X-TYPE

XT501-S948

Front Seat Stabilization Kit –
Change Of Specification –
Service Action S948

MODEL 2002-03 MY
X-TYPE

ILLUSTRATION 1

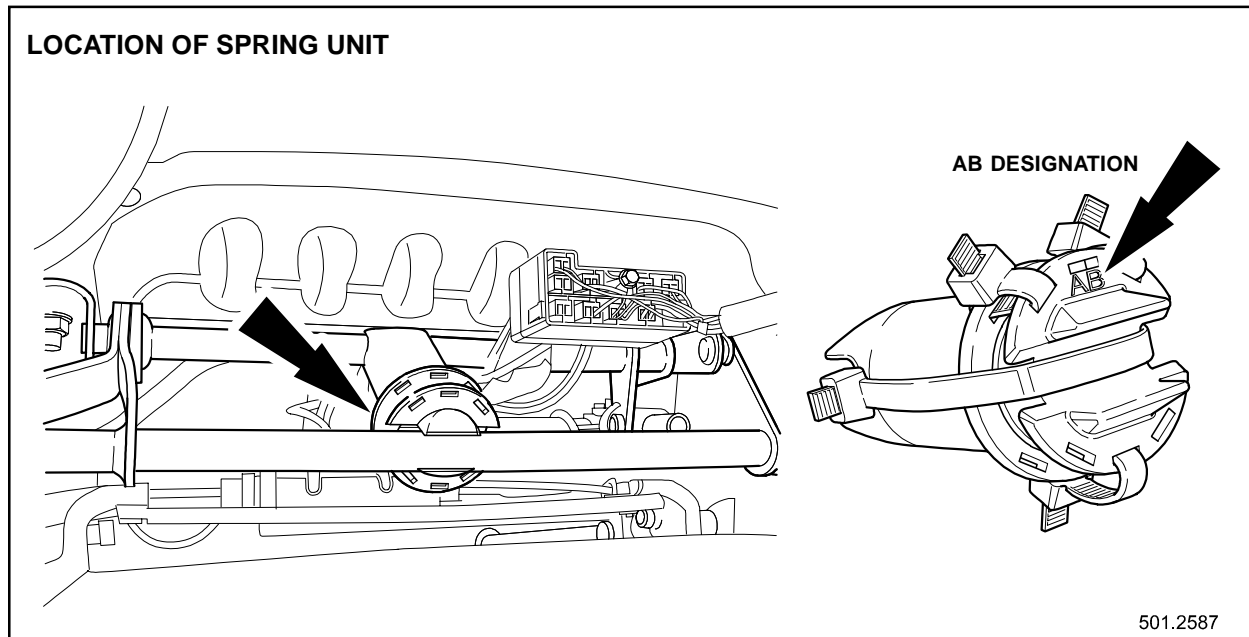
1. Check under seats to confirm the presence of spring unit without 'AB' markings. See Illustration 1.

ILLUSTRATION 3

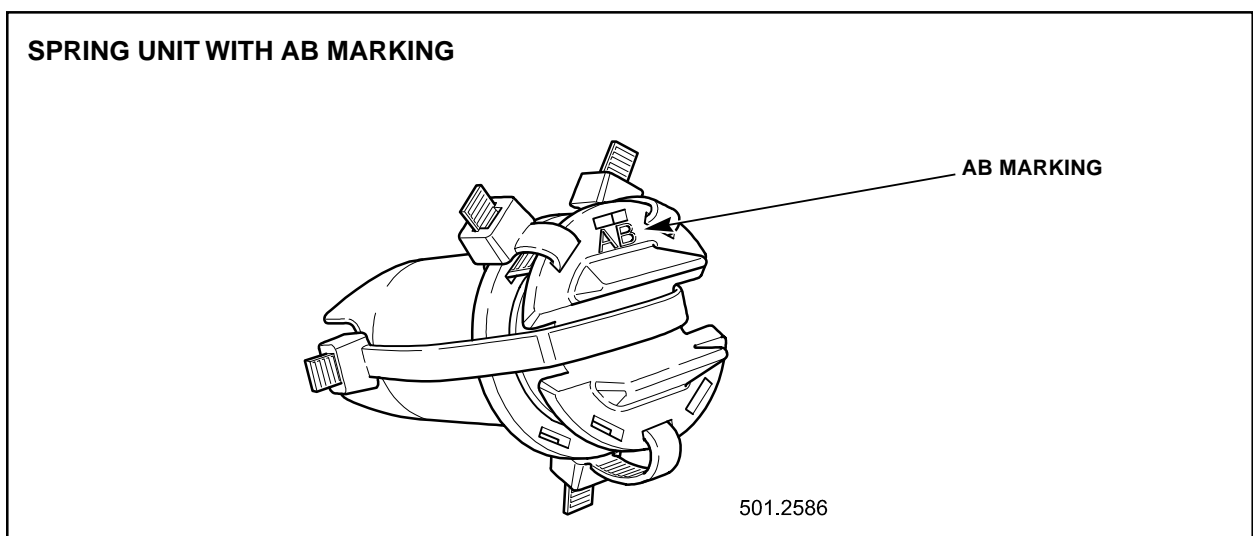
13. Place new spring unit, provided, (with 'AB' marking, see Illustration 3) to front.
